**STAFF RECOMMENDATION**  
**1510 Cedar Lane**  
**May 21, 2014**

**Application:** New construction-addition and outbuilding; Setback determination  
**District:** Belmont-Hillsboro Neighborhood Conservation Zoning Overlay  
**Council District:** 18  
**Map and Parcel Number:** 11704030700  
**Applicant:** Blaine Bonadies, Architect  
**Project Lead:** Sean Alexander, sean.alexander@nashville.gov

submittal for metropolitan historic zoning commission

architectural site plan  
 scale: 1/16"=1'0"

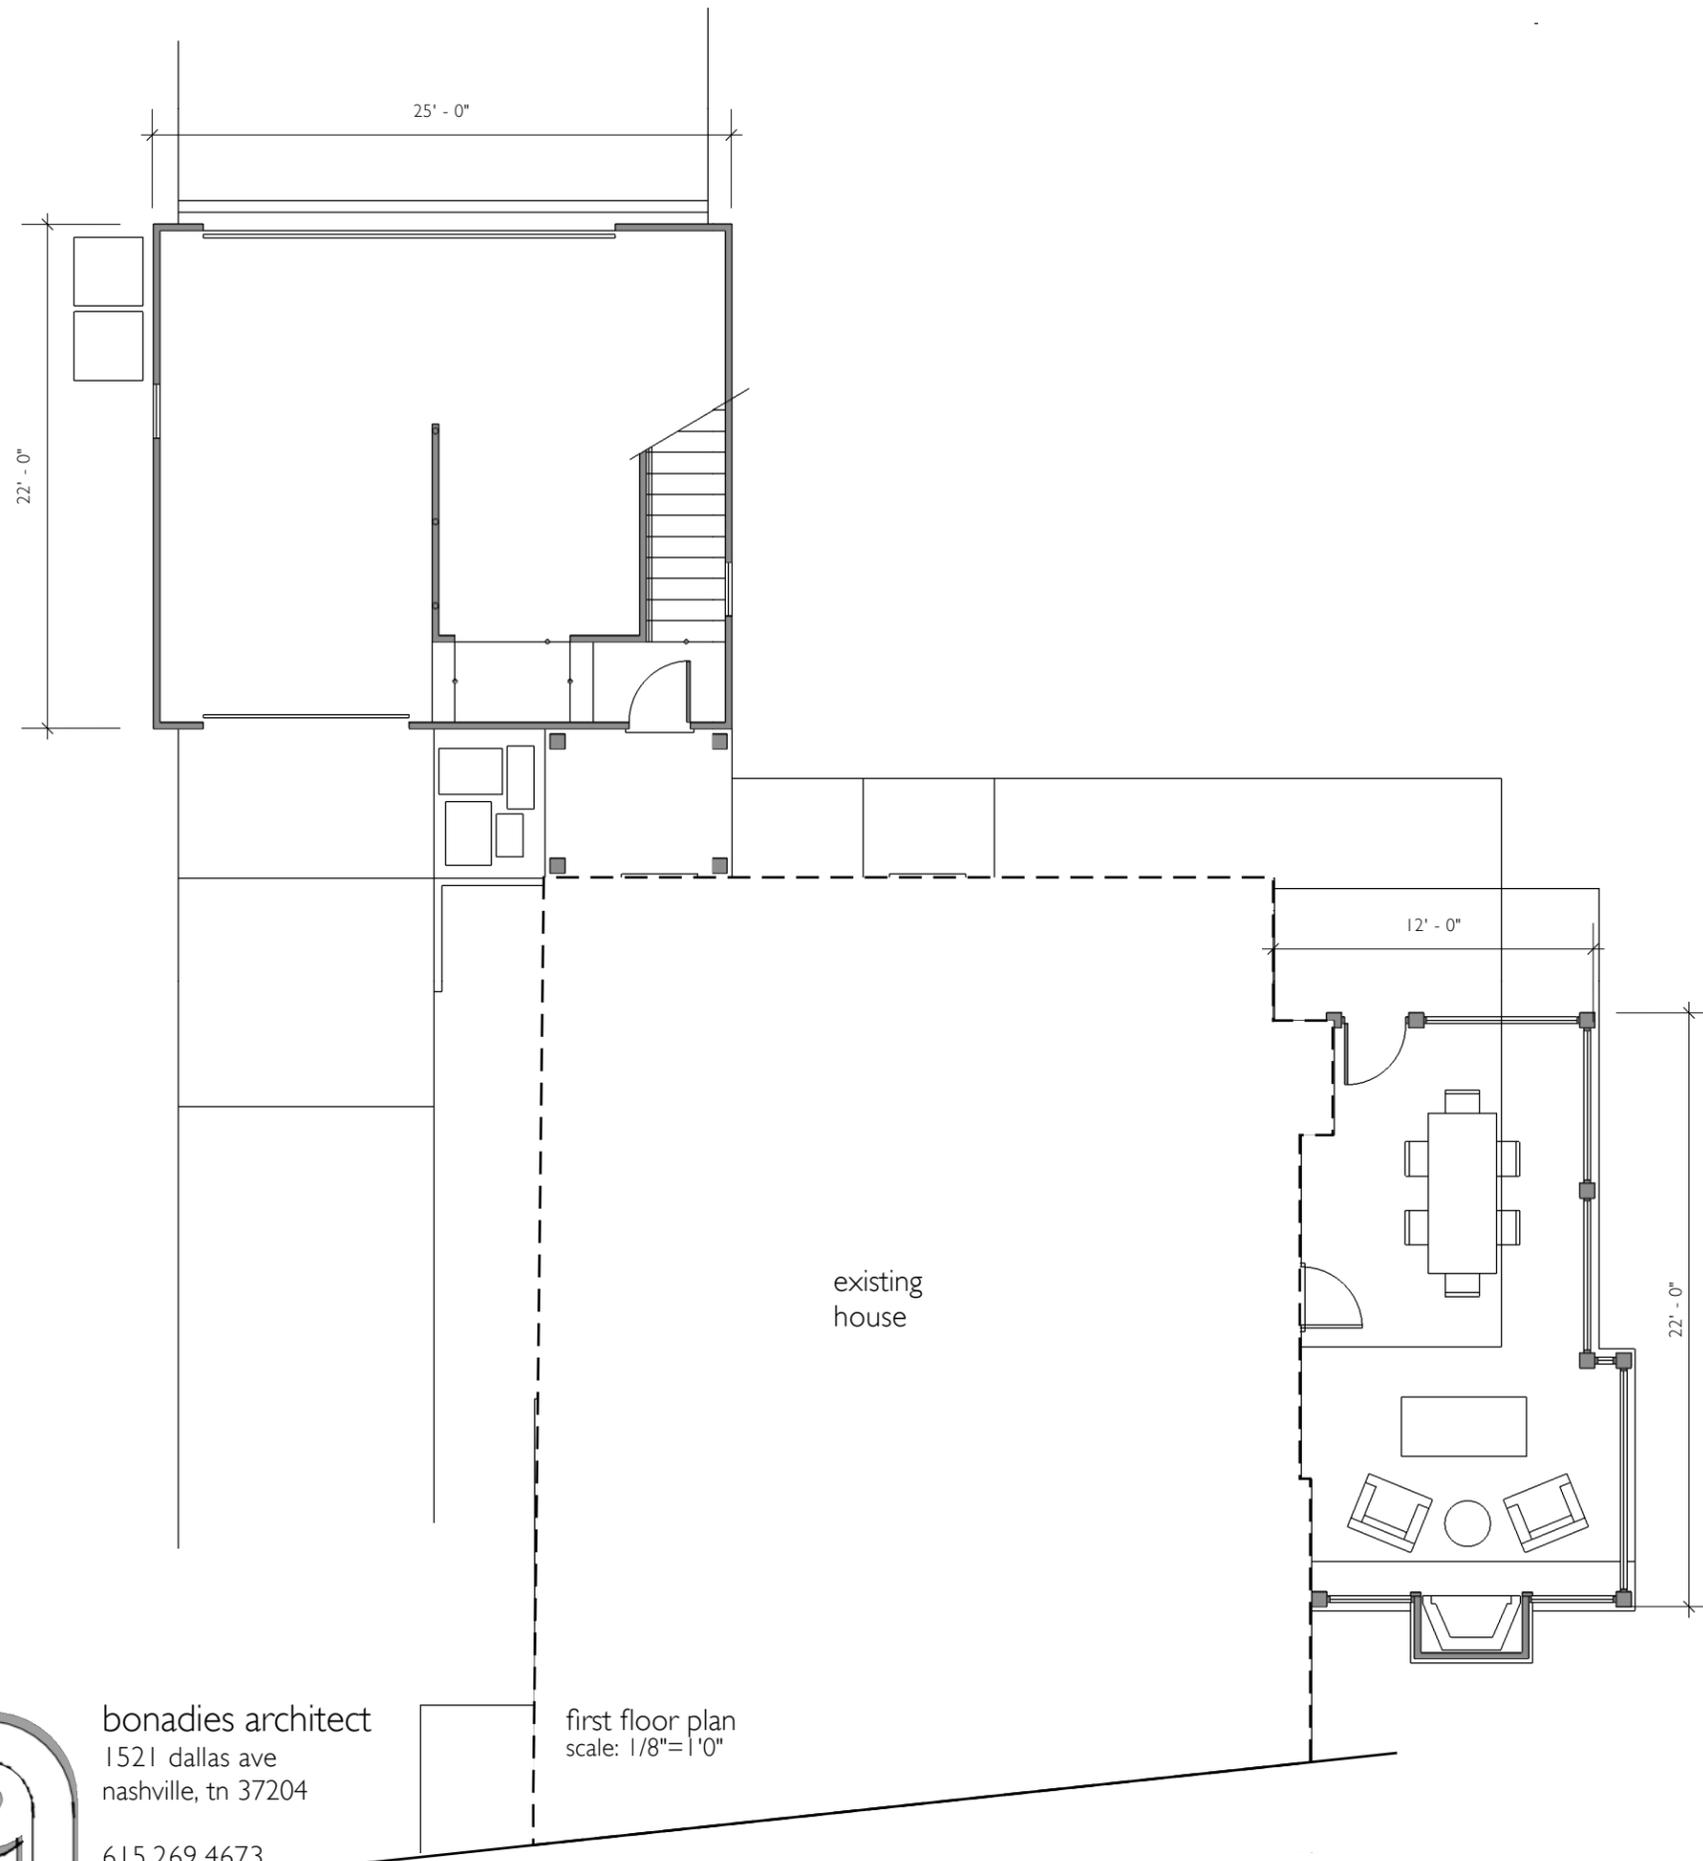
The addition to the right would not meet the standard five foot (5') side setback required by bulk zoning regulations. Staff finds that the proposed side addition would also not be in keeping with the established rhythm of spacing between historic buildings on the street.

The outbuilding will be located behind the house, eight feet (8') from the rear property line and four feet (4') from the left property line. This meets the standard side setback requirement, but encroaches on the rear setback by two feet (2'). The reduced rear setback is appropriate as historically outbuildings were often close to rear property lines.

- The width of the addition shall be reduced to meet the standard side-setback requirements;
- The materials of the brick and roof of the addition be approved by Staff;
- The pitch of the outbuilding roof shall be lowered to match the primary roof of the house; and,
- The windows and doors of the outbuilding be approved by Staff.

right elevation  
scale: 1/8"=1'0"

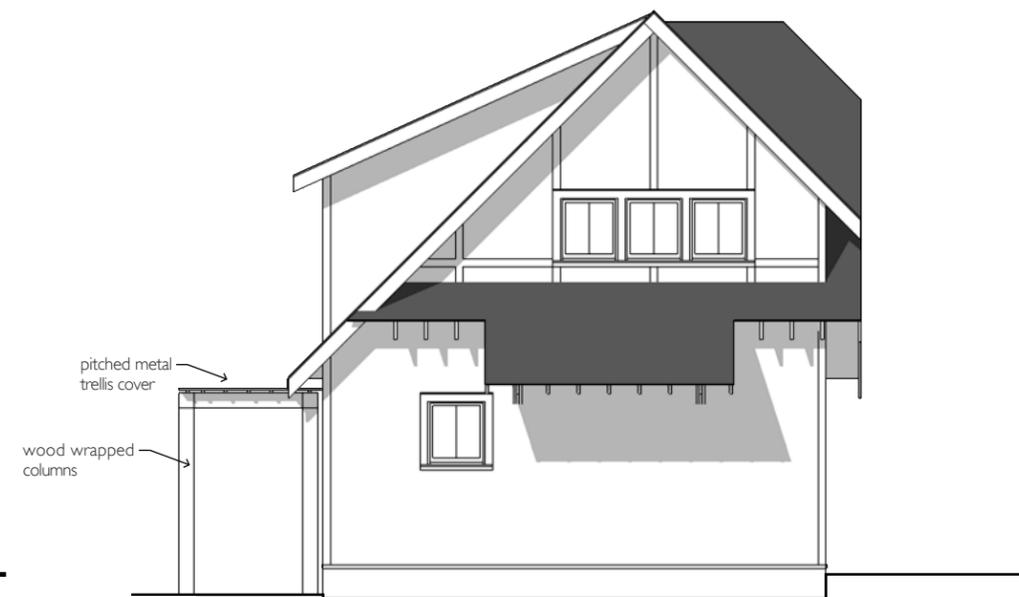
A new screened porch will be constructed at the rear-right corner of the house, thirty-three feet (33') back from the front edge of the house where there is an original rear porch that has been enclosed. The roof of the porch will tie into the right side of the house at twelve feet (12') above grade and shed down to eight feet (8') tall at the eaves. This height matches the proportions of the existing side addition. The porch will be fourteen feet (14') wide, extending four feet (4') further than the existing addition. Although a side addition may be appropriate because the lot is wider than sixty feet (60'), the new addition will encroach two feet (2') into the required side setback buffer. The Commission can approve construction that does not meet the standard setbacks when the result is more in keeping with the historic character of the district. However, Staff finds that the shorter setback would not be in keeping with the established rhythm of spacing between houses on Cedar Lane and does not meet the Commission's policy for setback determinations different than those required by the code's bulk standards.

No major changes to the historic house's materials were indicated on the drawings. The addition will have wood framing and columns and the vertical surfaces will be primarily wire screening. The material of the roof and fascia is not indicated. The plans also indicate a fireplace with a brick base and fiber cement chimney. Masonry is appropriate for chimneys, and fiber cement siding may be appropriate as panel siding with an applied skim-coat but not as lap-siding. More information is needed on the chimney and roof materials. The floor and foundation will be concrete slab-on-grade.

rear elevation  
scale: 1/8"=1'0"

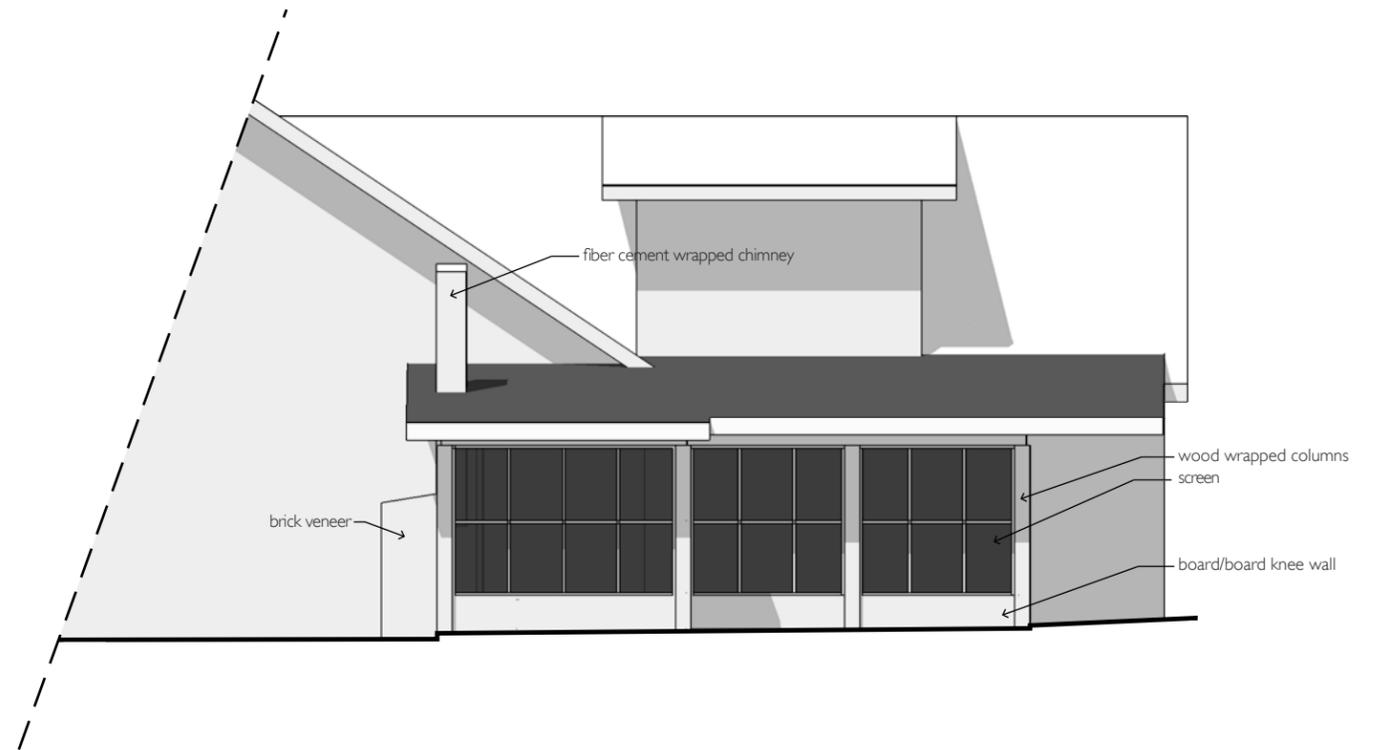
The roof of the new outbuilding will be an asymmetrical gable, similar to a saltbox, but it will read like a typical side-gable because the ridge is oriented side-to-side. The front slope of the garage will have a wall dormer, which Commission has approved for minimally visible rear elevations and outbuildings. The primary slopes of the roof will have a pitch 12:12 and the ridge height will be twenty-five feet (25') above grade. This height matches the height of the house, but the roof pitch is significantly steeper than the 8:12 pitch of the roof on the house which would not be appropriate.

Lowering the pitch of the garage roof to match the roof of the house would lower the ridge by four feet (4'), which will help to make the outbuilding more subordinate to the house and would meet guidelines II.B.1.a and II.B.1.e.
